HARTZELL PROPELLER INC.
SERVICE BULLETIN
TRANSMITTAL SHEET
HC-SB-30-375
De-ice - Wire Harness Replacement

This page transmits a revision to Service Bulletin HC-SB-30-375.

Revision 1 is issued to change the following in the Service Bulletin:

HARTZELL PROPELLER INC.
SERVICE BULLETIN
HC-SB-30-375
De-ice - Wire Harness Replacement

Visual Inspection
Figure 1

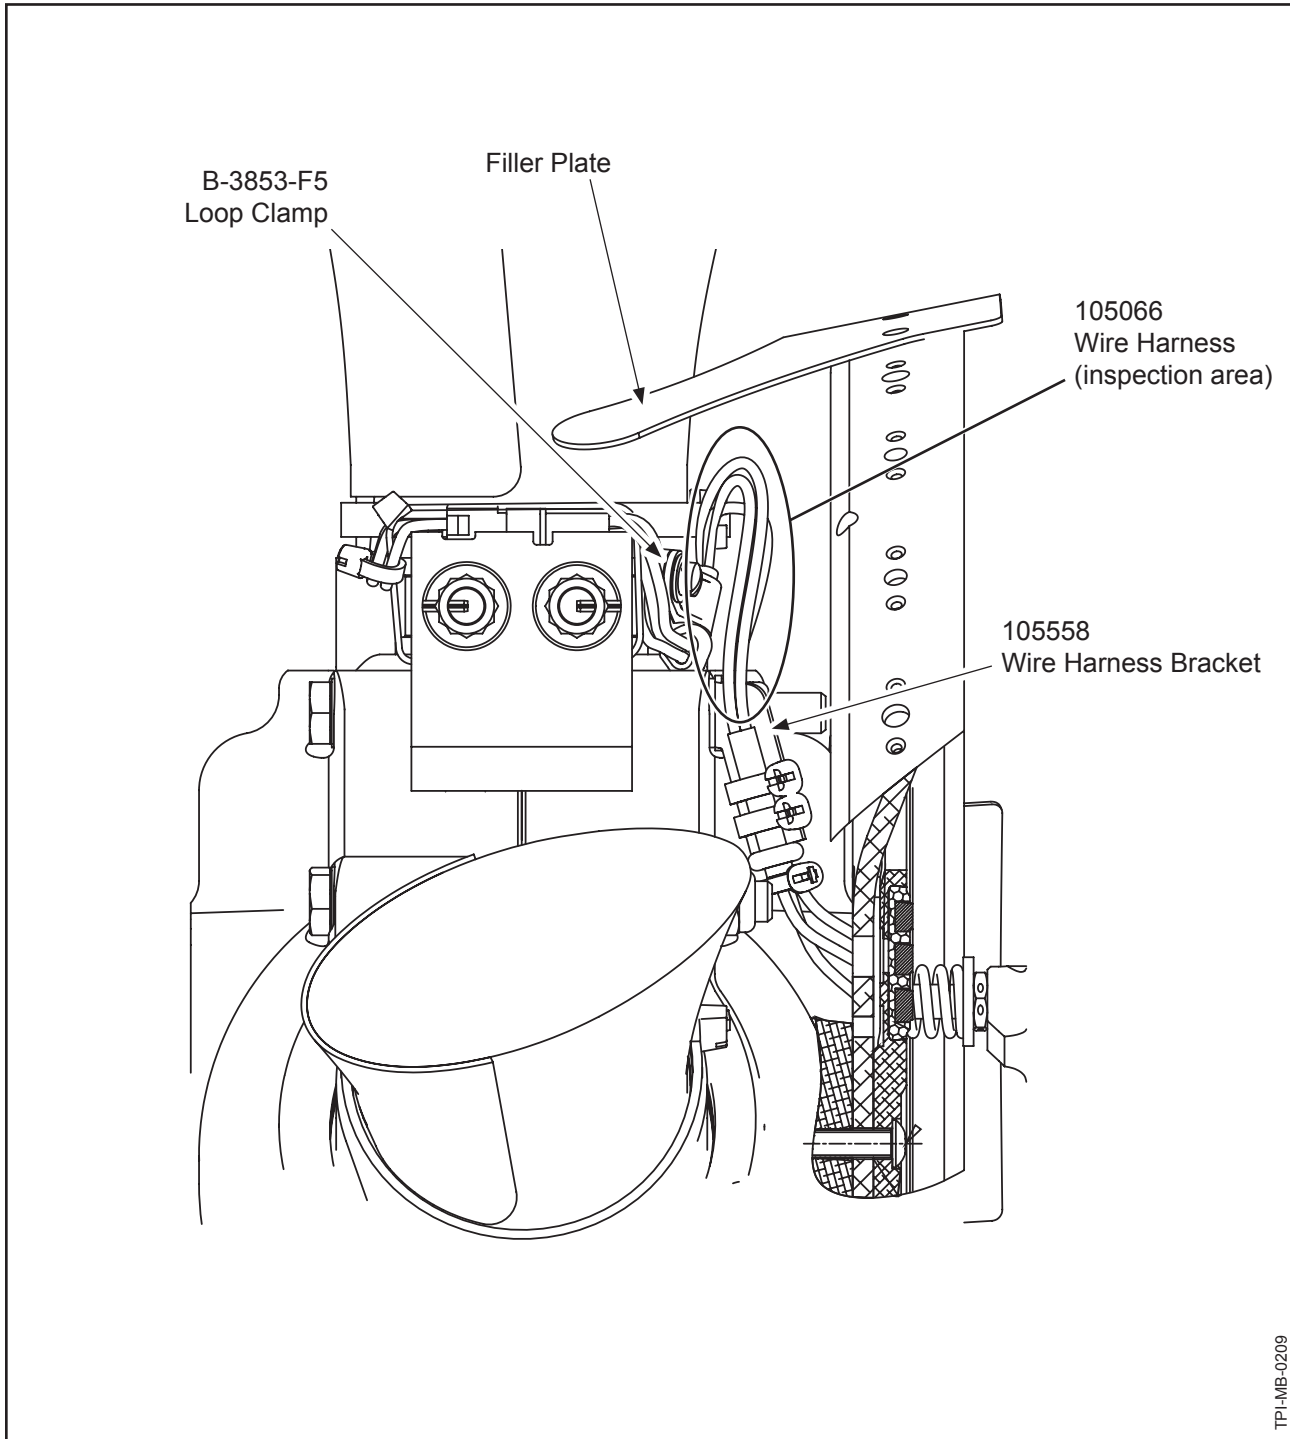
- (a) Examine all three wires on each 105066 wire harness for cuts or damage to the insulation between the B-3853-F5 loop clamp and the 105558 wire harness bracket. Refer to Figure 1.

- 1 If there is no damage to any of the 105066 wire harnesses, replace all five 105066 wire harnesses with five 105555 wire harnesses in accordance with the Accomplishment Instructions in this Service Bulletin within 50 flight hours from the visual inspection.

- 2 If the first layer of insulation (black) on any of the 105066 wire harnesses is damaged but the copper wire is not exposed, replace all five 105066 wire harnesses with five 105555 wire harnesses in accordance with the Accomplishment Instructions in this Service Bulletin within 25 flight hours from the visual inspection.

- 3 If the copper wire on any of the 105066 wire harnesses is exposed, replace all five 105066 wire harnesses with five 105555 wire harnesses in accordance with the Accomplishment Instructions in this Service Bulletin before further flight.

Wire Harness to Blade Shank/Counterweight
Figure 2

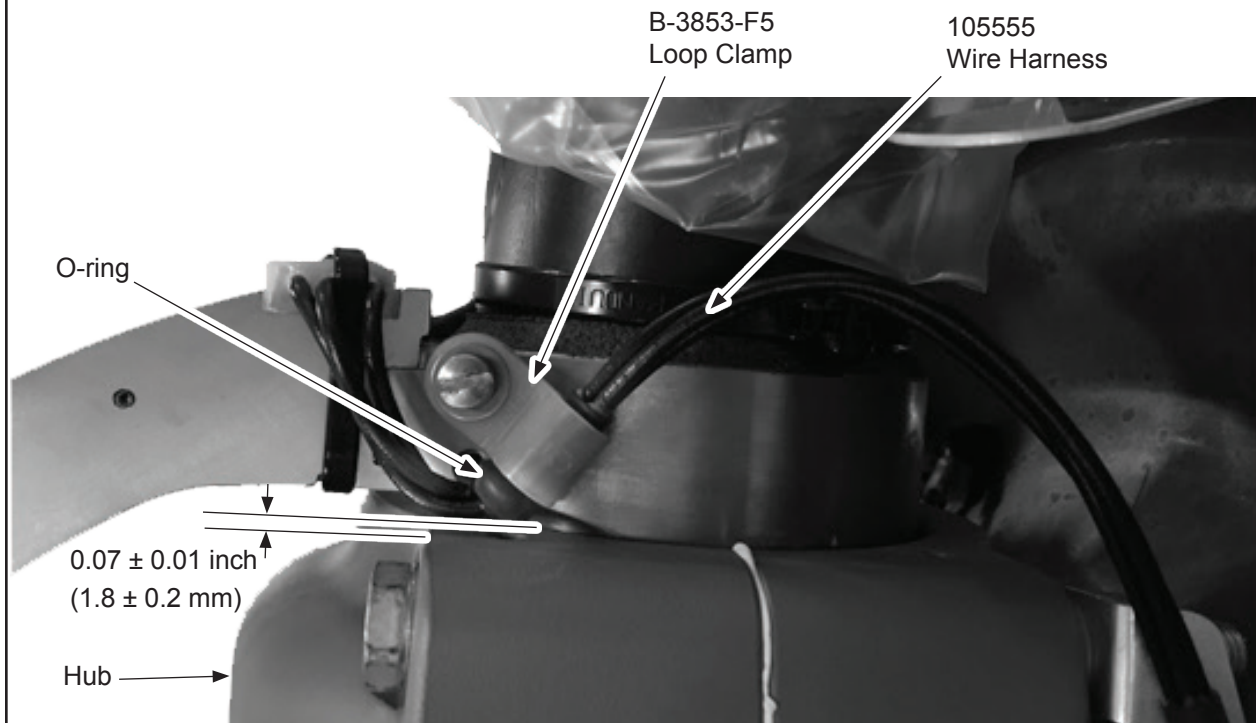
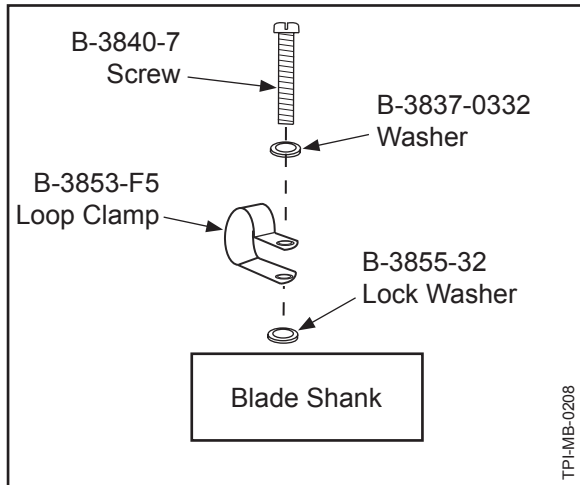
- (4) Remove all of the tie straps that attach the 105066 wire harness to the de-ice boot plug, counterweight, and wire harness bracket. Refer to Figure 2.

- (2) Assemble the plug connection between the 105555 wire harness and the de-ice boot plug.
- (3) Install the wire harness/de-ice boot plug connections in the counterweight groove against the spring pin as shown in Figure 2.

- (a) On the de-ice boot-side of the plug connection, install the B-3852-2-0 tie strap between wire 2 and wire 3 as shown in Figure 2.
 - (b) On the wire harness-side of the plug connection, install the B-3852-2-0 tie strap between wire 1 and wire 2 as shown in Figure 2.

- (c) Put the head of the B-3852-2-0 tie strap in the approximate location shown in Figure 2.
- (5) Using the B-3852-5-0 tie strap, secure the de-ice boot lead wires to the B-3852-2-0 tie strap as shown in Figure 2.

B-3853-F5 Loop Clamp Installation
Figure 3

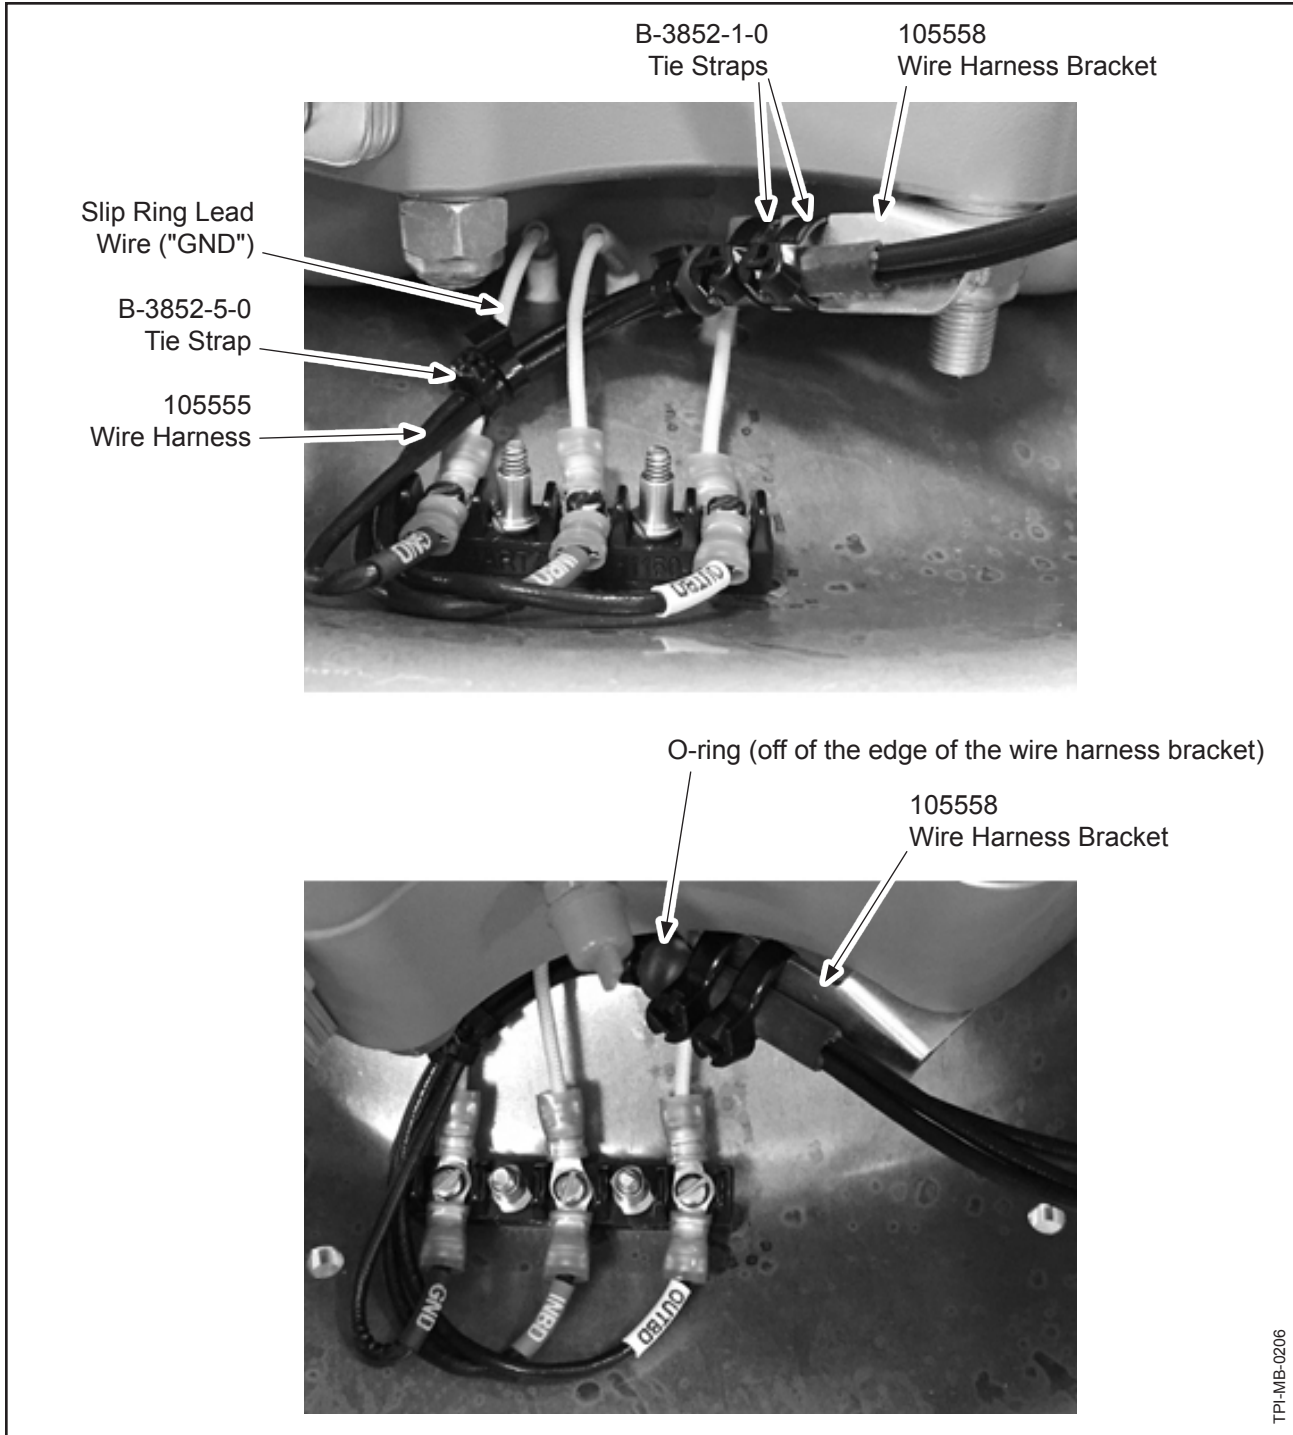
- (5) Remove the B-3840-7 screw, B-3855-32 lock washer, B-3837-0332 washer, and the B-3853-F5 loop clamp that attaches the 105066 wire harness to the blade shank. Refer to Figure 3.
- (6) Disconnect the plug connection between the 105066 wire harness and the de-ice boot plug.
- (7) Disconnect the 105066 wire harness leads from the bulkhead terminal strip.
- (8) Remove and discard the 105066 wire harness.
- (9) Repeat steps 3.B.(4) thru 3.B.(8) for each 105066 wire harness on the affected propeller.
- (10) Keep the propeller blades at reverse angle to install the 105555 wire harnesses.

- (6) Install the B-3853-F5 loop clamp around the 105555 wire harness and put it against the O-ring as shown in Figure 3.
- (7) Apply threadlocker CM116 to the threads of the B-3840-7 screw.

- (8) Using the B-3840-7 screw, B-3837-0332 washer, and the B-3855-32 lock washer, attach the B-3853-F5 loop clamp to the blade shank in accordance with Figure 3.
 - (a) Align the B-3853-F5 loop clamp so that there is 0.07 ± 0.01 inch (1.8 ± 0.2 mm) clearance between the O-ring and the hub as shown in Figure 3.
 - (b) Torque the B-3840-7 screw to 15-18 In-Lb (1.7-2.0 N•m).
- (9) Put the 105555 wire harness on the 105558 wire harness bracket with the O-ring off of the edge of the wire harness bracket as shown in Figure 4.

Terminal Strip Connections
Figure 5

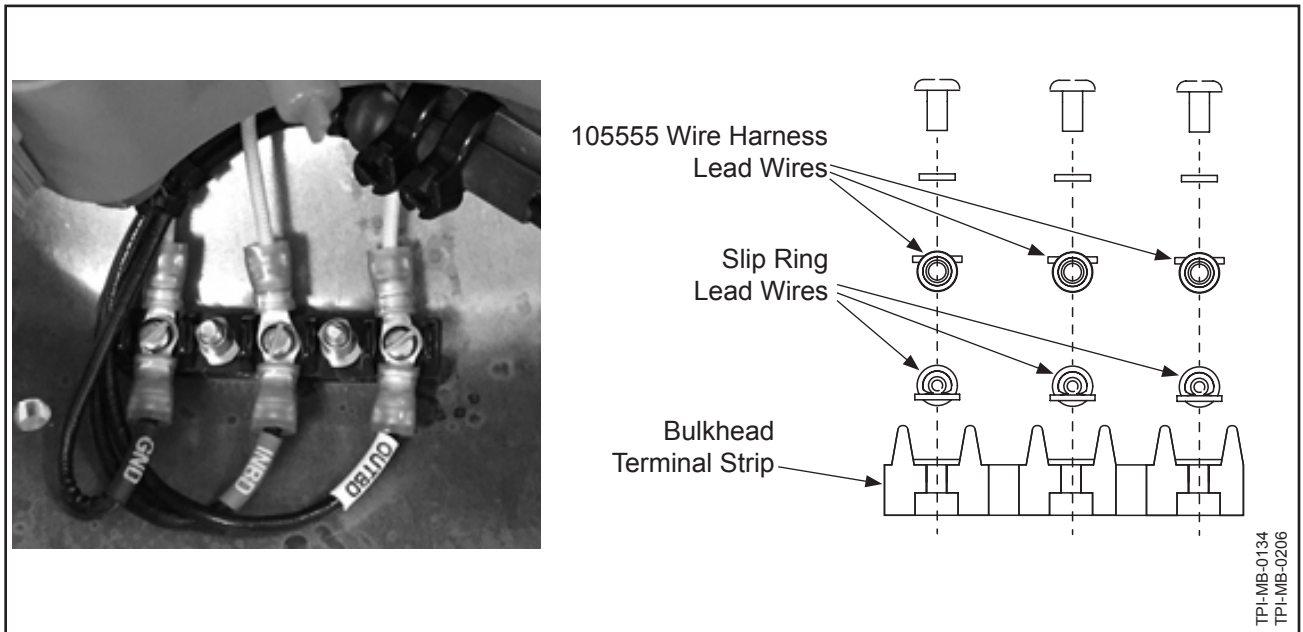
- (11) Attach the slip ring lead wires and the lead wires from the 105555 wire harness to the bulkhead terminal strip in accordance with Figure 5.
- (a) Using one B-3852-5-0 tie strap, attach the lead wires from the 105555 wire harness to the ground ("GND") slip ring lead wire as shown in Figure 4.
 - (b) Tighten the terminal strip screws until snug.
- (12) Repeat steps 3.C.(3) through 3.C.(11)(b) for each blade.
